Re: PG&E Comments - Proposed Statewide Policy for Once-Through Cooling (CWA  
Section 316(b) Regulations)

**PACIFIC GAS & ELECTRIC COMPANY'S  
COMMENTS REGARDING  
PROPOSED STATEWIDE POLICY ON CLEAN WATER ACT § 316(B)  
REGULATIONS  
SEPTEMBER 15, 2006**

**FIGURE 2- Industrially Zoned Area**

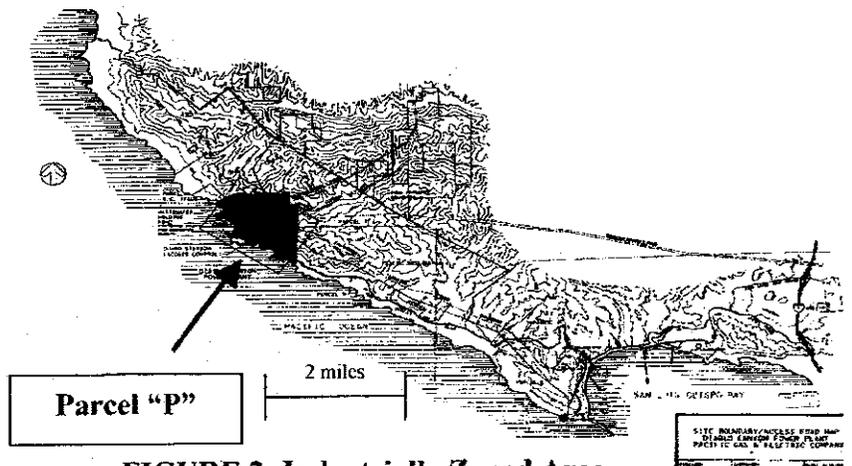
Roughly 25% of the land in Parcel P is able to support construction. The gradient of the rest is simply too steep. Existing structures and parking lots already occupy nearly all of the usable space.

**FIGURE 4 - Tetra Tech's Proposed Siting of the Cooling Towers[1]**  
**(This is a duplicate of Figure 2 from Tetra Tech's November 2002 report)**

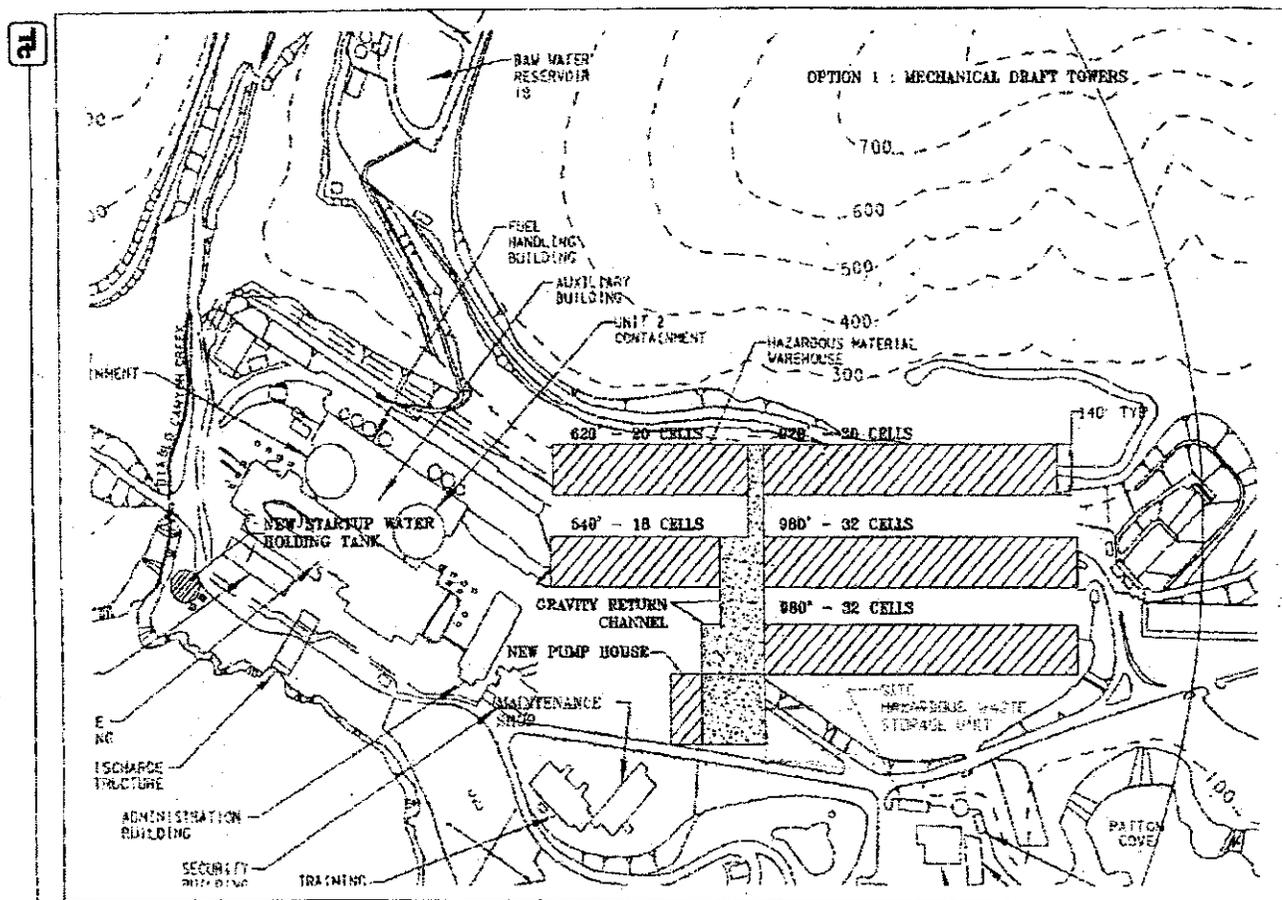
1. **Tetra Tech's proposal overestimates the amount of available space at DCPP for the proposed towers.** Burns Engineering Services agrees with Tetra Tech that 132 large saltwater, counterflow mechanical draft tower cells would be required at DCPP to cool its 1,725,000 gpm of salt water if conversion to a closed-cycle system were required. That proposed arrangement is shown on page 15 of the Tetra Tech report[1] and is reproduced in this report under Figure 4. Rather than locate a suitable area for the cooling tower retrofit, the Tetra Tech proposal simply displaces several existing plant structures for which there is no alternative space within the industrially zoned area of the site. The net effect is that the Tetra Tech report does not adequately address the lack of available land for the project.

Tetra Tech has proposed displacing a substantial area in the center of the marine terrace for construction of the cooling towers (see below). Each of the cooling towers proposed have a 60' x 60' footprint. The total area required would be roughly 1600' long and 600' wide. The construction would be a massive project, extremely costly in terms of both money and time.

**FIGURE 8- Salt Drift Patterns from Tera Corporation Report, lb/acre-yr  
(In contrast, typical ambient salt deposition from ocean ~86 lb/acre-year)**

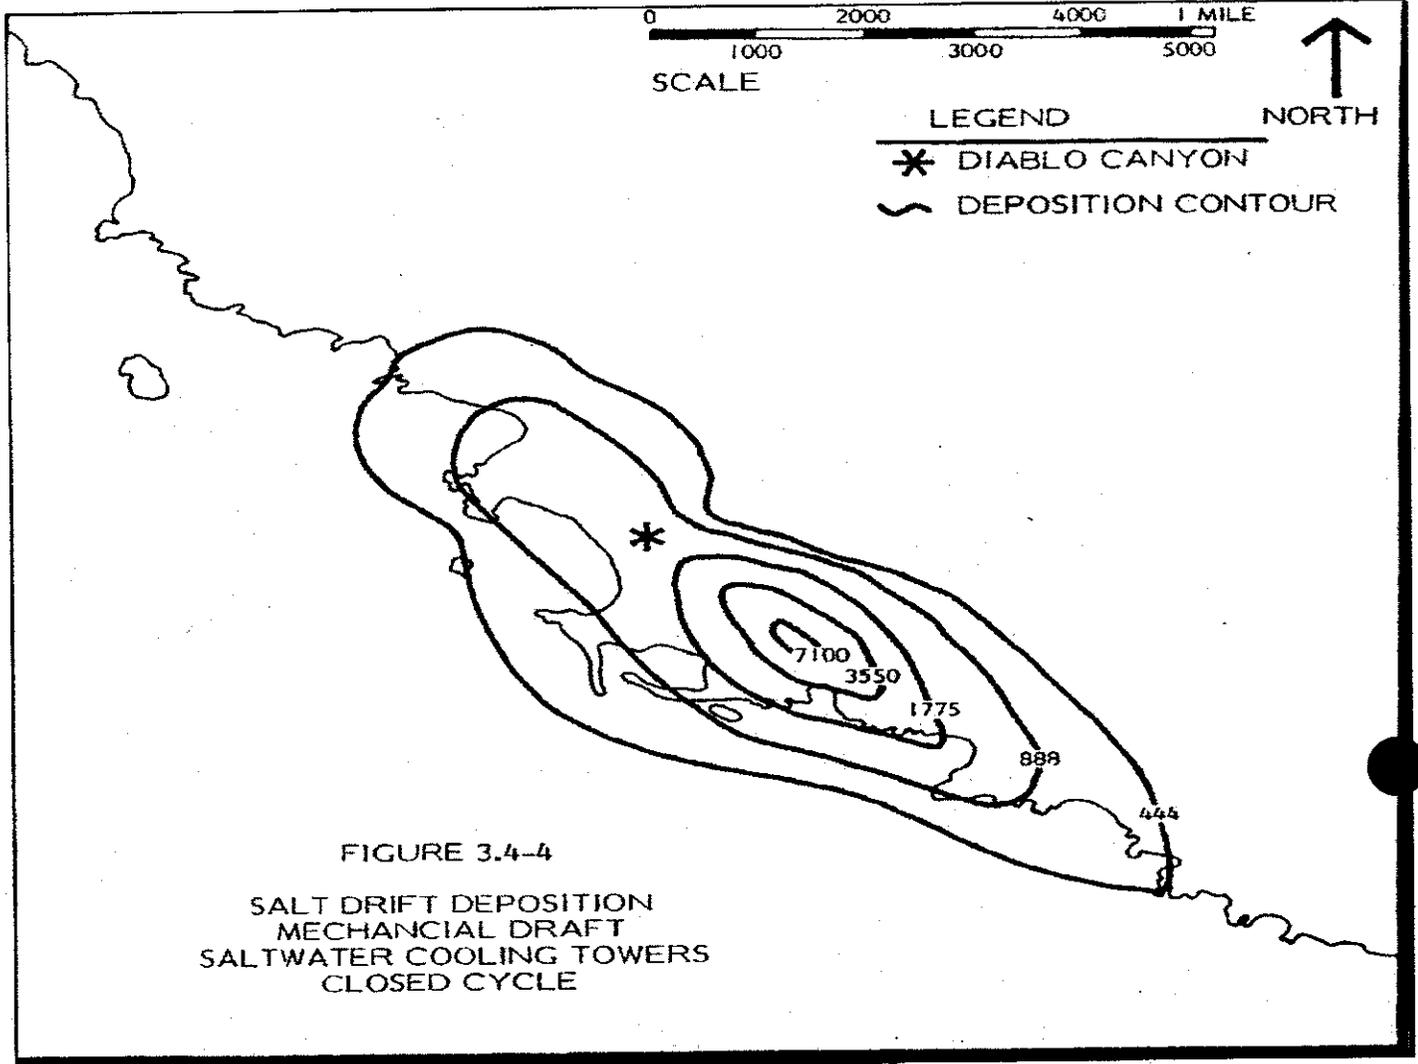
Tera Corp. [14] has modeled likely patterns of drift for mechanical draft cooling towers sited in the general area proposed by Tetra Tech for the cooling towers. See Figure 6 on the following page. Salt will blanket an area extending beyond the plant boundary to the north and south. The center of highest salt deposition will occur approx. 1/3 mile south of the cooling towers within the plant boundary at the southeast section of parcel P. However, a substantial amount will settle over the agricultural zone as well.

deposited salt on the insulator. Salt will inevitably settle upon the closely situated insulators of the 500 kva power lines resulting in forced shutdown of the facility and higher maintenance costs.

Figure 2: Mechanical Draft Cooling System Layout

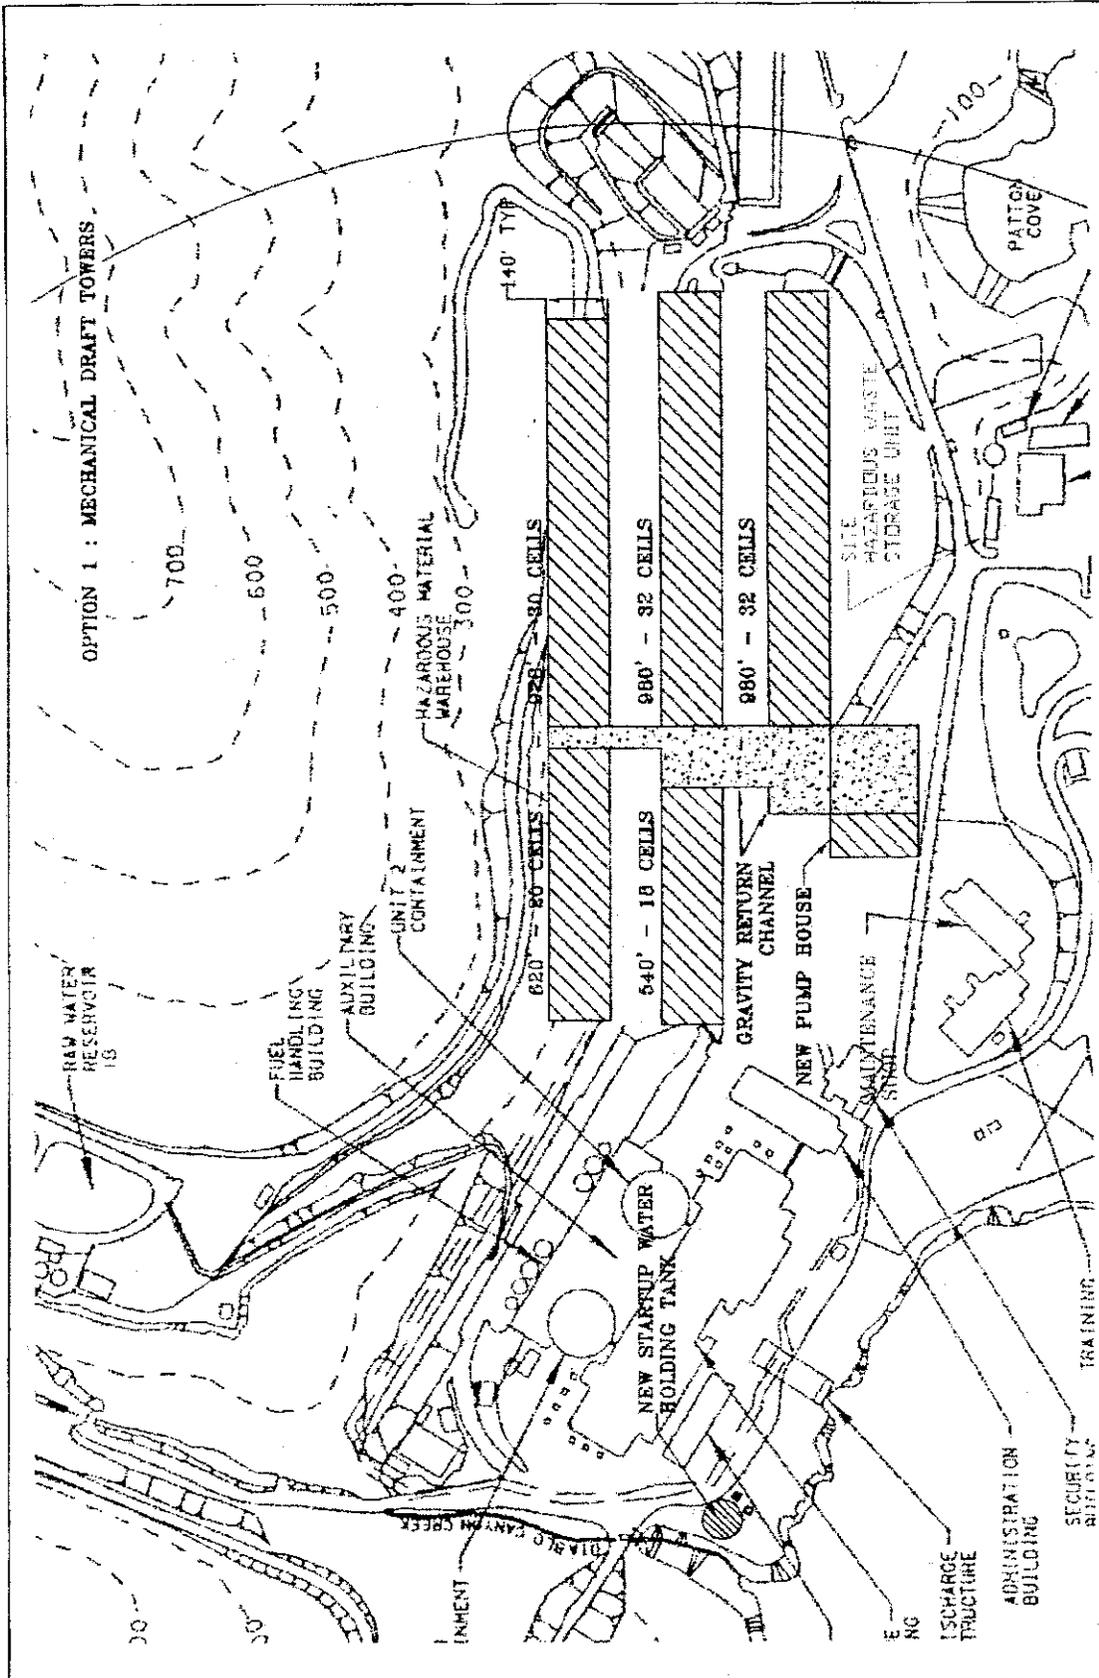
6. **Plume from the cooling towers will create safety and security hazards.** The proposed Tetra Tech 132-cell wet mechanical draft design would produce a substantial vapor plume during the cool weather periods that frequently occur at DCPD. Access roads, buildings and parking lots could be blanketed by those opaque, very visible plumes. The Figure 7 photo of an actual plume illustrates that a lack of visibility occurs even with much smaller towers. The lack of visibility for this proposed site would constitute a safety and security hazard, particularly when considering transporting nuclear fuel for processing or disposal. The cool, damp, conditions common at DCPD will make the formation of these large, opaque plumes a frequent occurrence.

The proposed Tetra Tech ~132 cell wet mechanical draft design as shown in Figure 2 of their report would produce a substantial plume during certain periods. A plume looks like a massive cloud of smoke that would rise from the tower stacks and would be more than just an aesthetic nuisance. A plume is formed when the relatively warmer saturated exhaust air mixes with cooler ambient air after leaving the stack. The frequency and intensity of a plume are related to heat load and atmospheric conditions. The measure of visible intensity or opacity of a plume is exacerbated when the ambient air temperature becomes cooler as colder air cannot hold as much moisture.
